RAI 3.6.2.2.2-1a (High Voltage Insulators)

LRA 3.6.2.2.2 Degradation of Insulator Quality due to Presence of Any Salt Deposits and Surface Contamination, and Loss of Material due to Mechanical Wear

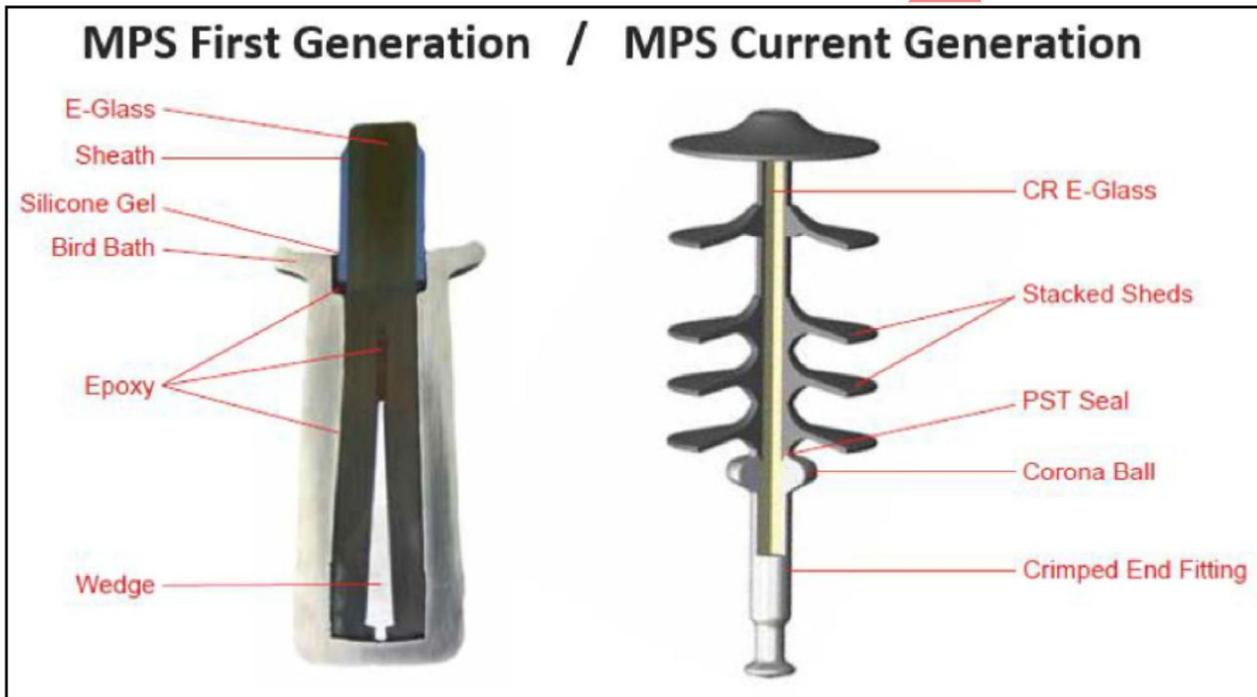
1. Explain why epoxy, silicone gel, sealants, and ductile iron are not listed in the response to RAI 3.6.2.2.2-1 as materials that are used in construction of polymer high-voltage insulators.

Information from the manufacturer (MacLean Power Systems or MPS) of the RBS polymer insulators does not discuss "ductile iron" for the corona ring or the end fittings, which are the only metal components on the insulators. The connection hardware does include ductile iron.

The RBS polymer high-voltage insulators are a recent generation of MPS polymer insulators that have been manufactured since 2007. The RBS polymer insulators do not use epoxy. The following figure shows the difference between the first generation of MPS polymer insulators and the generation of MPS polymer insulators that are used at RBS.

The MPS polymer insulators in service at RBS use a PST sealing system, which is a triple seal design. The triple seal or PST seal comprises the primary seal (P), the secondary seal (S), and the tertiary seal (T). The primary seal is a silicone rubber sheath compressed into the chamfer of the crimped end fitting. The secondary seal is RTV (room temperature vulcanizing) silicone applied to the rod, sheath, and end fitting interface. The tertiary seal is a final external RTV silicone seal applied to the sheath and end fitting interface. The RBS polymer insulators do not utilize silicone gel. The response to RAI 3.6.2.2.2-1 included silicone rubber, but did not explicitly identify RTV silicone as a type of silicone rubber. The silicone rubber material includes the RTV silicone that is part of the PST seal system. The RBS polymer insulators do not include silicone gel or sealants other than RTV silicone.
